LOWELL STREET ASSESSMENT DISTRICT - 2024

CITY PROJECT NO. 14078
CONTRACT NO. 8712

Addendum 1 - RSD March 13, 2024
- SBE Pre Bid meeting rescheduled to March 18, 2024
Addendum 2 - RSD March 21, 2024
- Updates to specs and to U-1, U-6, And U-7
Revision 1 - AJZ July 18, 2024
- Changes to Title Sheet, EC-1, P-1, GI-1, U-1, U-2, U-5, U-6

14078SWR-GI - 723 SOUTH SHORE
LOWELL ST RECONSTRUCTION
M:\DESIGN\Projects\14078\CAD\Sewers\14078SWR-GI.dwg

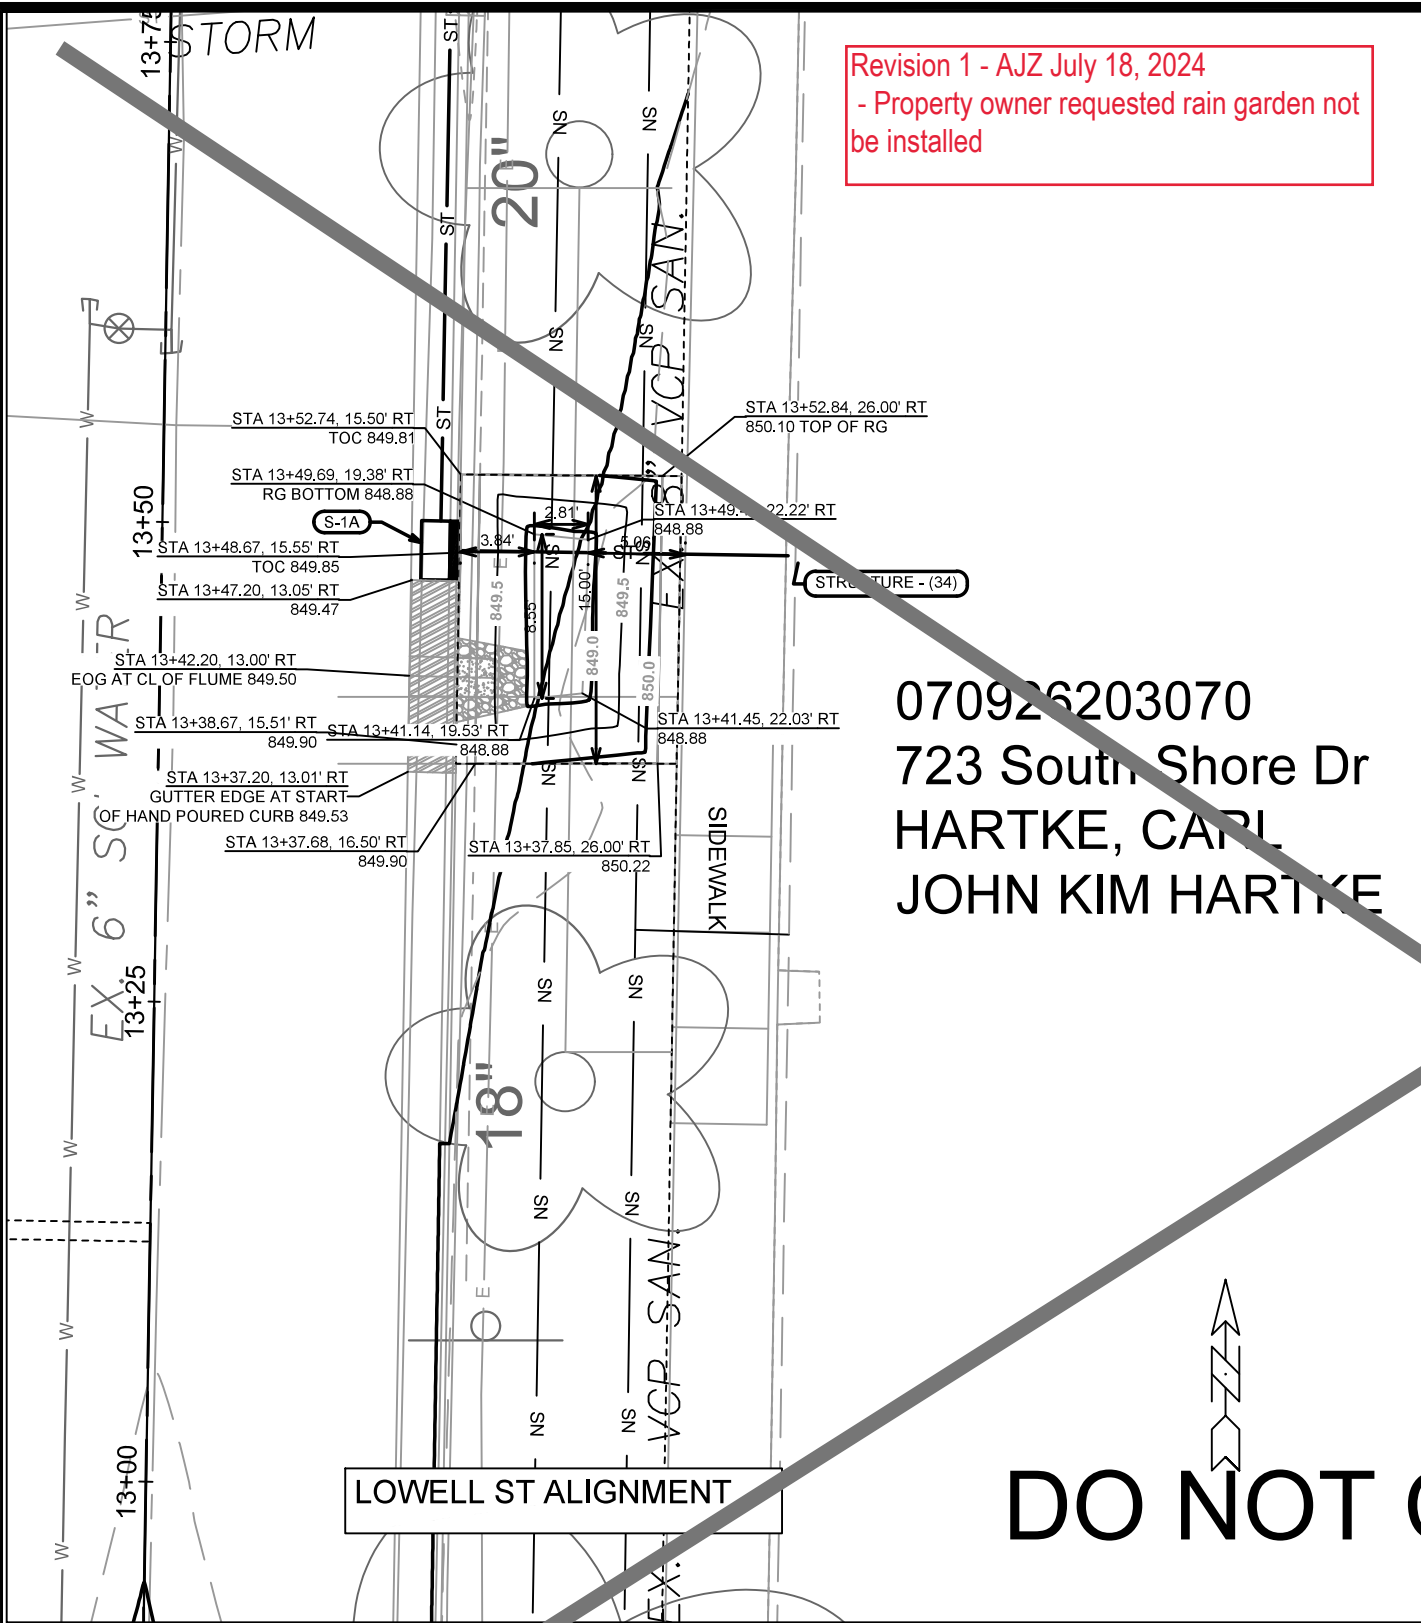
Revision 1 - AJZ July 18, 2024
- Property owner requested rain garden not be installed

U-1

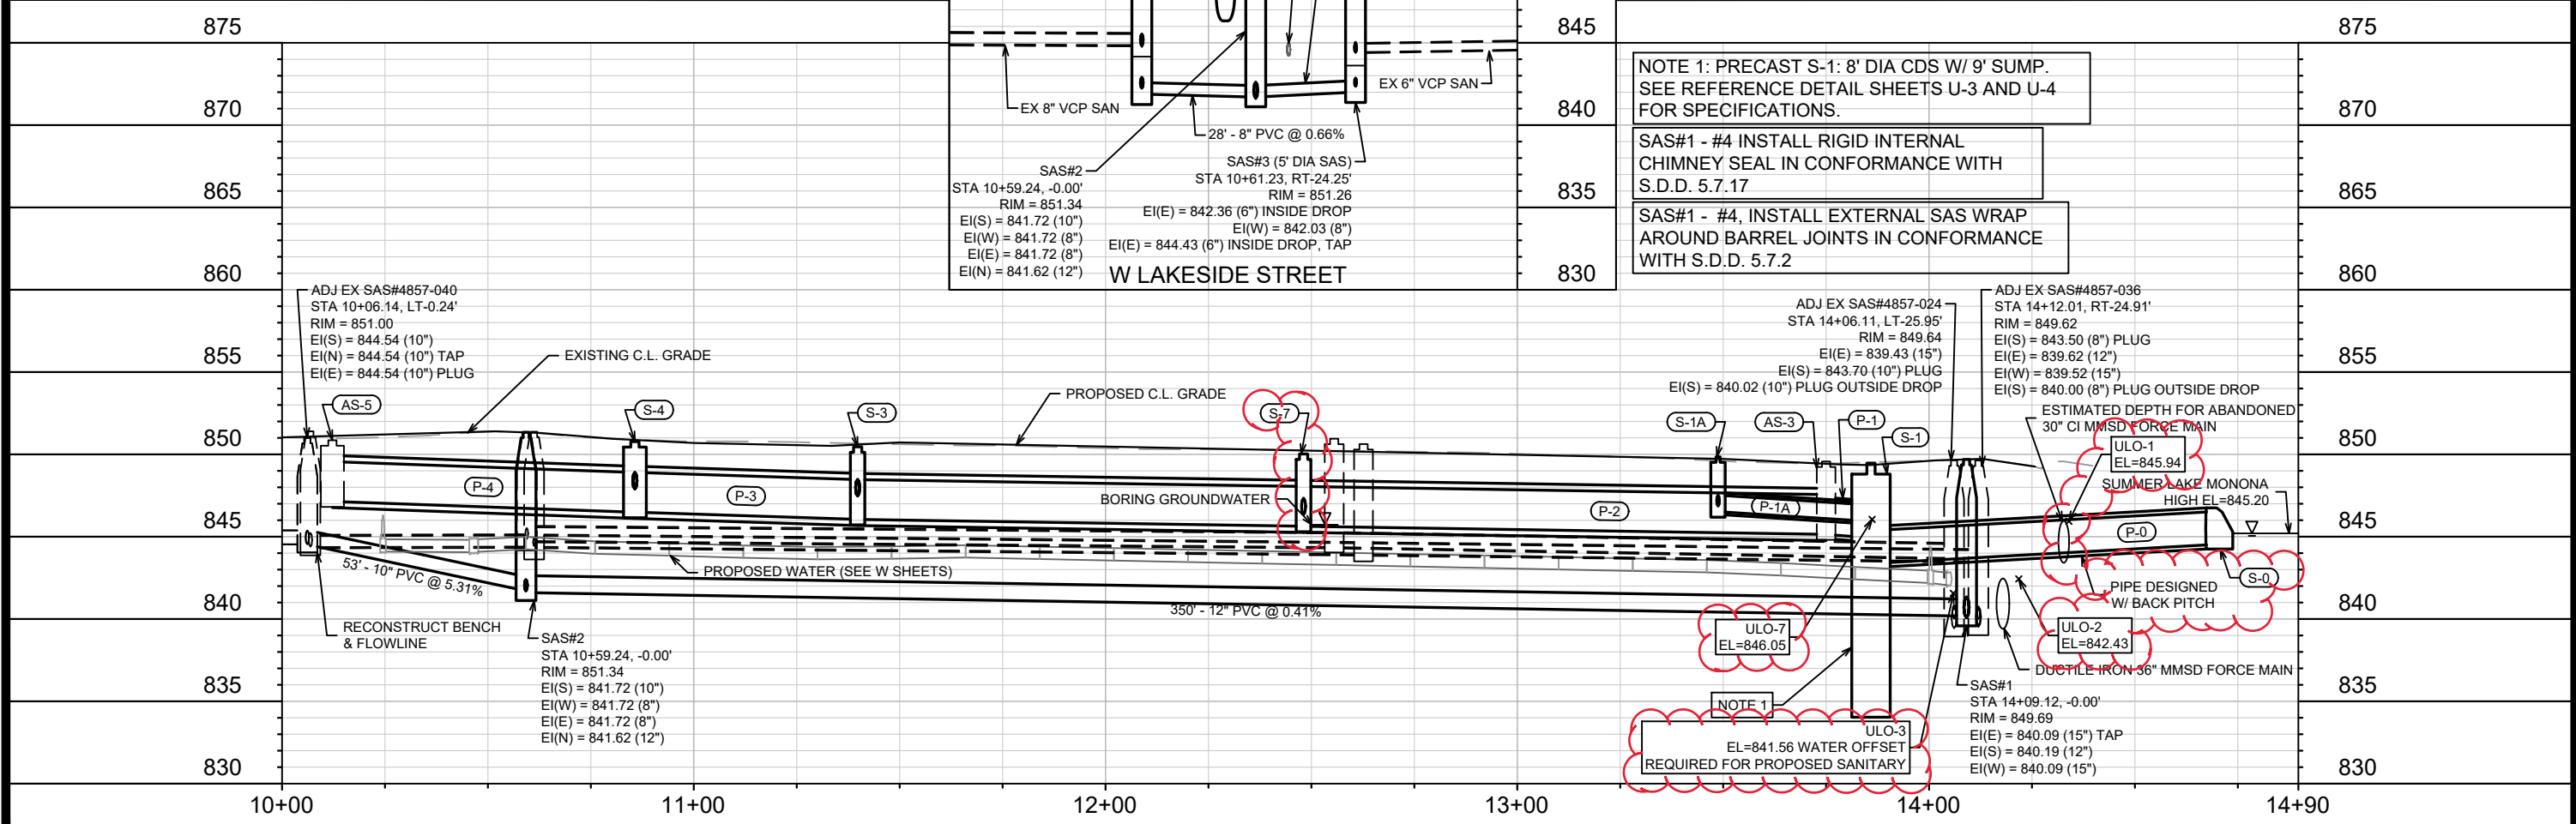
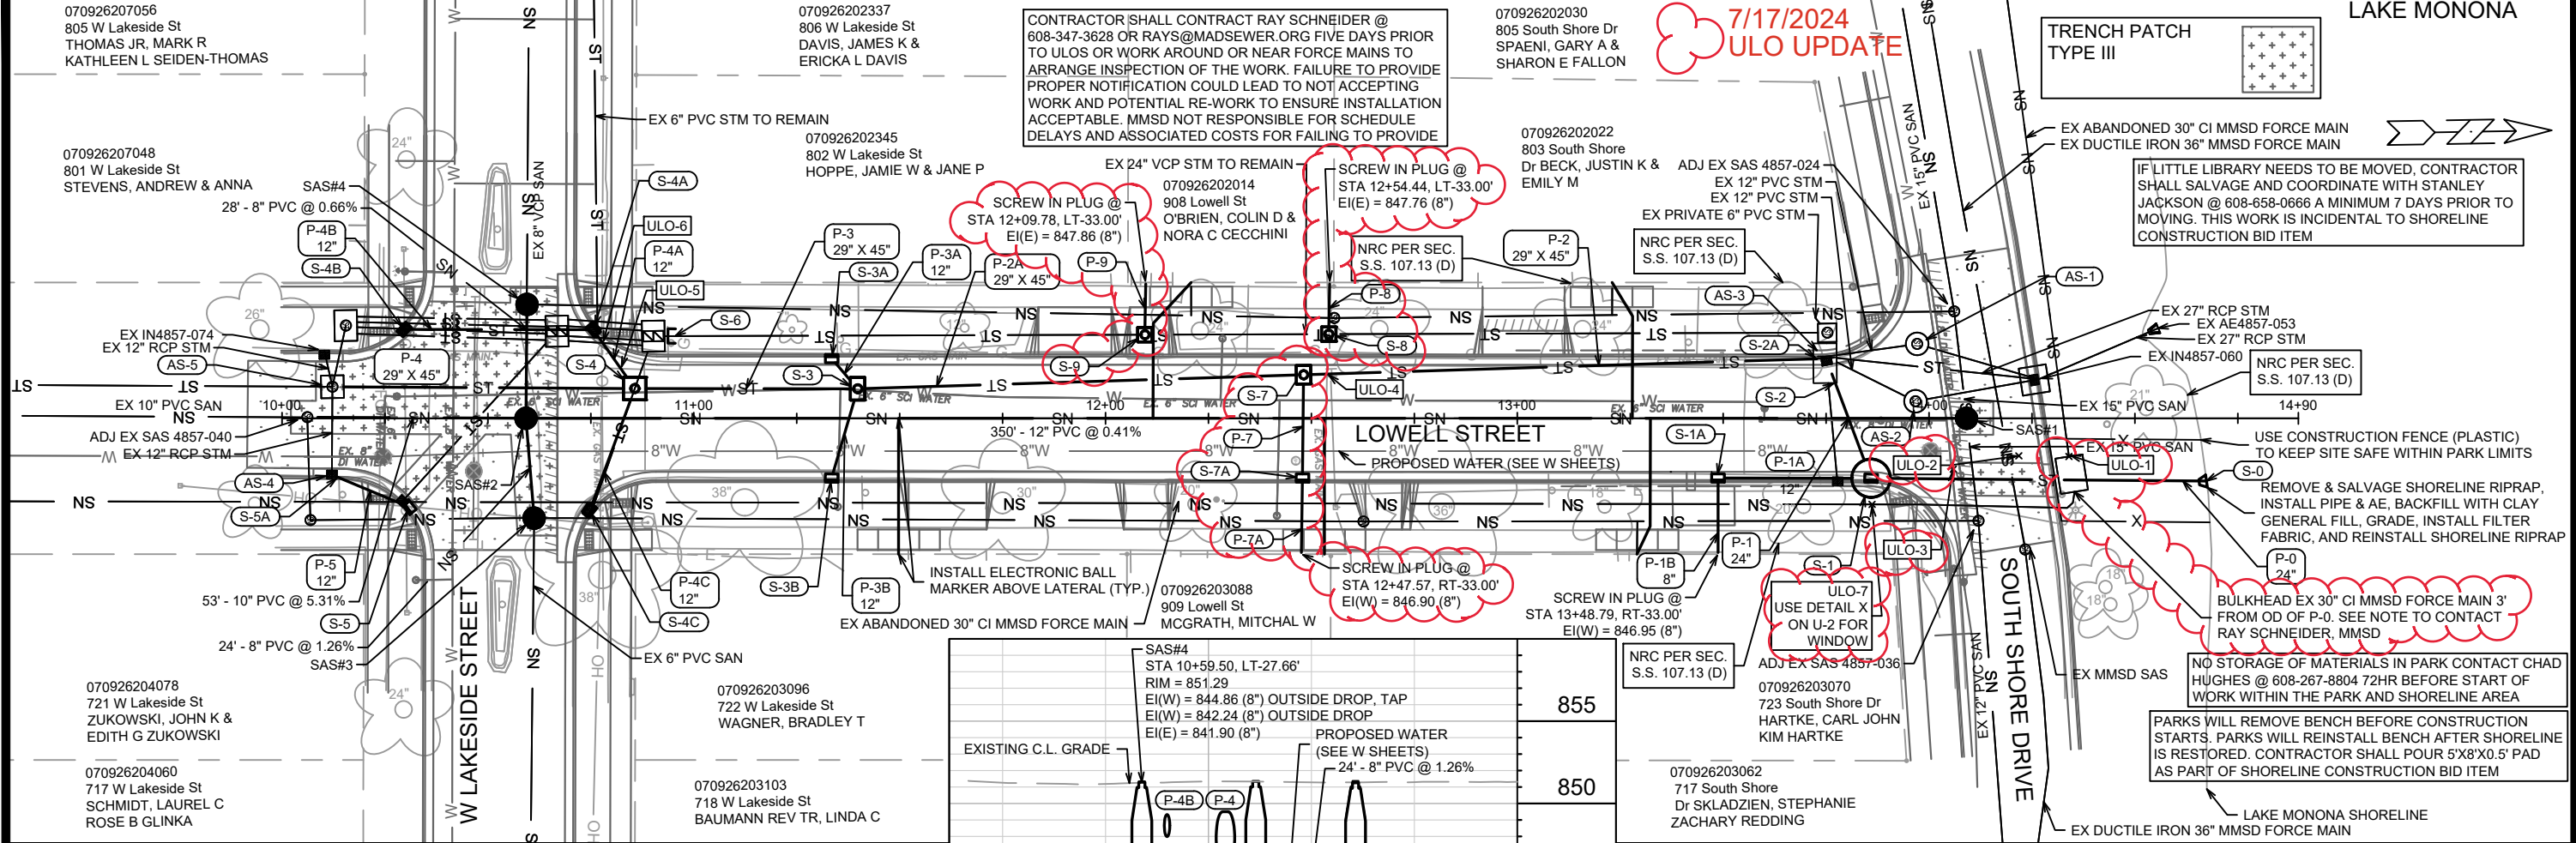
IF LITTLE LIBRARY NEEDS TO BE MOVED, CONTRACTOR SHALL SALVAGE AND COORDINATE WITH STANLEY JACKSON @ 608-658-0666 A MINIMUM 7 DAYS PRIOR TO MOVING. THIS WORK IS INCIDENTAL TO SHORELINE CONSTRUCTION BID ITEM

USE CONSTRUCTION FENCE (PLASTIC) TO KEEP SITE SAFE WITHIN PARK LIMITS
REMOVE & SALVAGE SHORELINE RIPRAP, INSTALL PIPE & AE, BACKFILL WITH CLAY GENERAL FILL, GRADE, INSTALL FILTER FABRIC, AND REINSTALL SHORELINE RIPRAP

NO STORAGE OF MATERIALS IN PARK CONTACT CHAD HUGHES @ 608-267-8804 72HR BEFORE START OF WORK WITHIN THE PARK AND SHORELINE AREA

PARKS WILL REMOVE BENCH BEFORE CONSTRUCTION STARTS. PARKS WILL REINSTALL BENCH AFTER SHORELINE IS RESTORED. CONTRACTOR SHALL POUR 5'X8'X0.5' PAD AS PART OF SHORELINE CONSTRUCTION BID ITEM
